Intel[®] Ethernet Controller I210

Specification Update

Revision 3.0
332763-014

7. WGI210CS Automotive Industrial Temperature Fiber Schematic

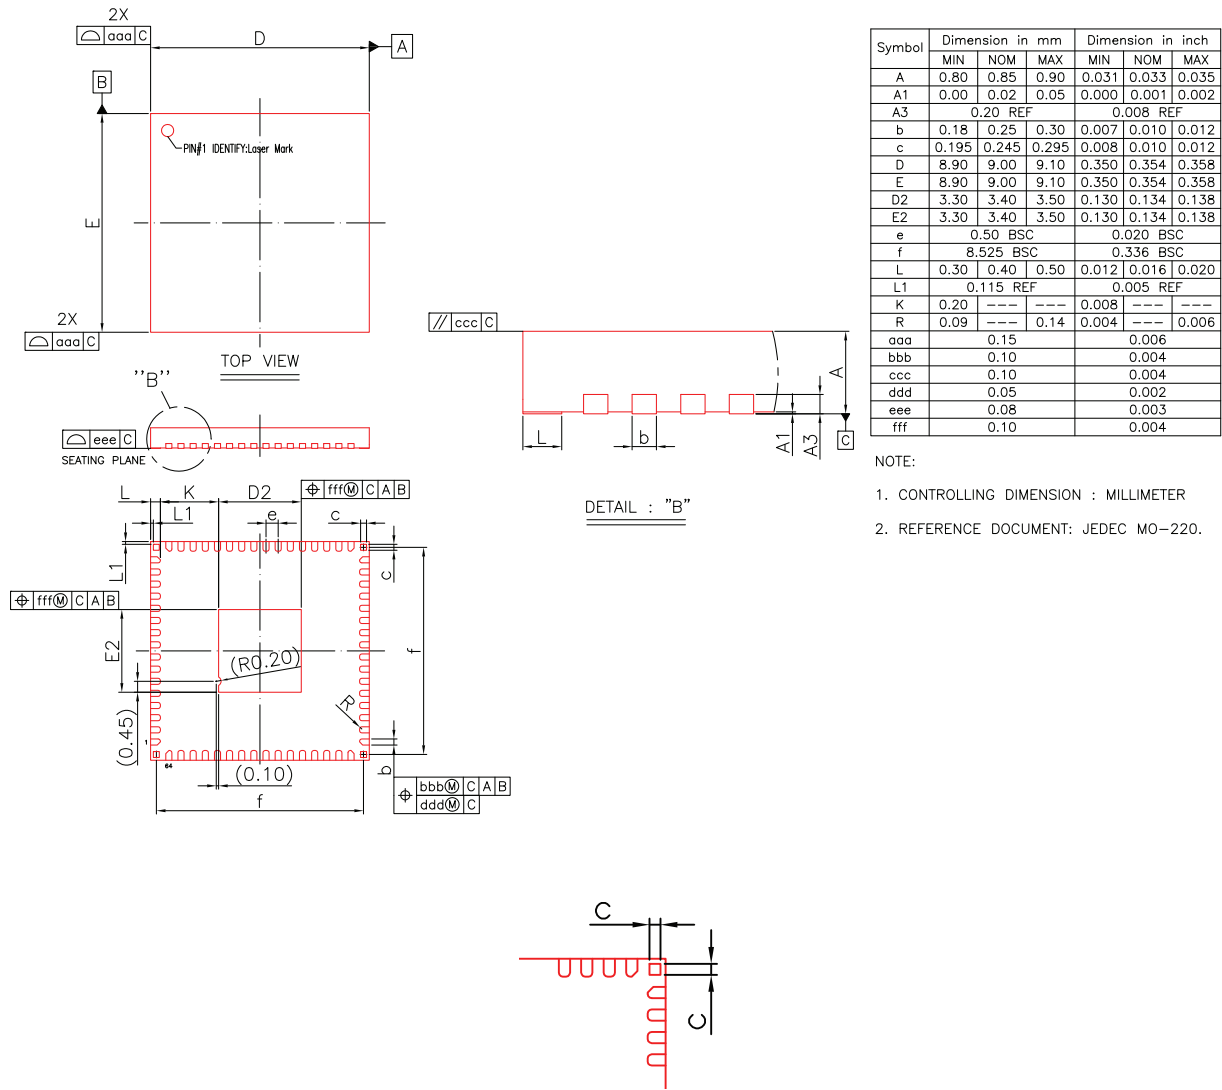
Note: The I210 CS has four no-connect corner pads for added solder joint reliability (as shown in Detail C).
